ADDENDUM FOR ORT6617/2021/RFP:

Summary of scope clarifications during site inspection conducted on the 23rd of September 2021

Figure 5: Bund wall local control panel - marked gap to be closed

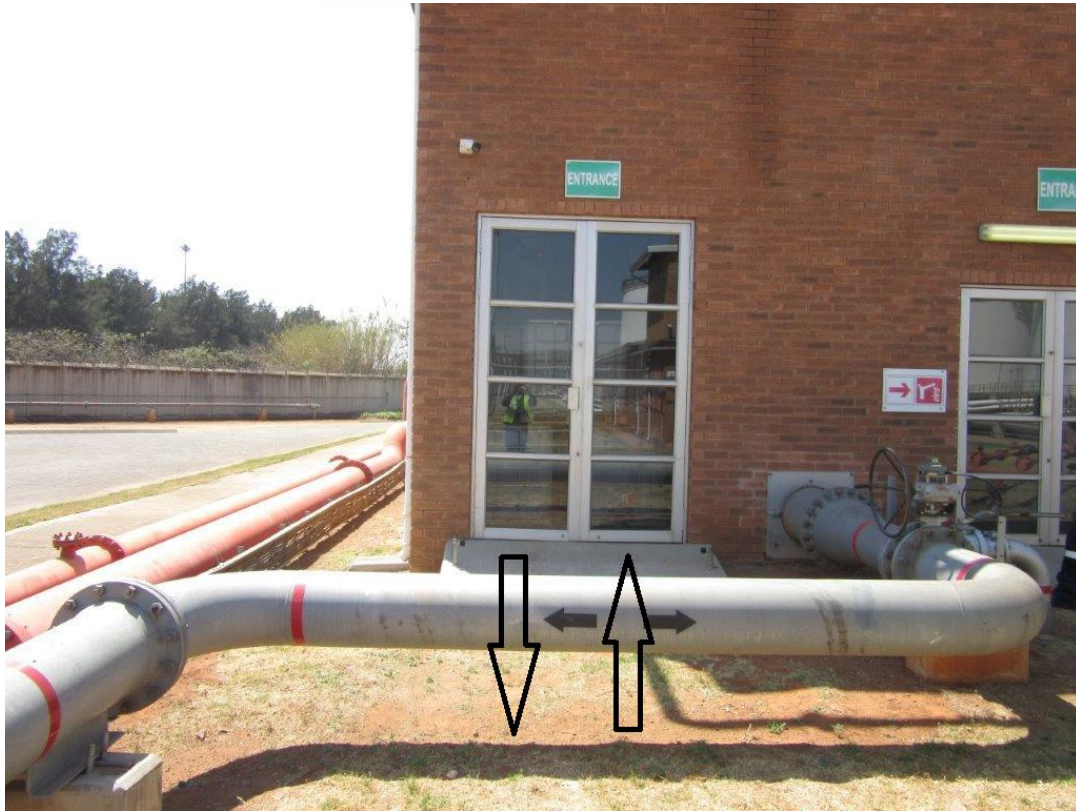
- Walling and/or plating to cover the gaps behind the bund wall panels of tank farms 1 and 2.
 - 2 walls are to be built in order to prevent heat of fire from encroaching into panels
- Application of intumescent and cementitious fire-resistant material to bund wall cabling and to cabling leading to storage tank input and output automated valves. A sheath, covering or enclosure for all storage tank input and output actuated valves. All fire-resistant material applied and/or installed shall be specified to resist a fire of at least 1,500 °C for a period of no less than 20 minutes.
 - Quantities for tank farms 1 and 2 (tanks 1, 2, 3, 4, 5, 6, 7, 8, 9, 10, 11) is 3 actuated valves
 - Total quantity is 33 flanges
- Provide fire resistant cladding to long bolt flanges. Pipe sizes and flange joint lengths vary and are to be measured and quantified before execution.
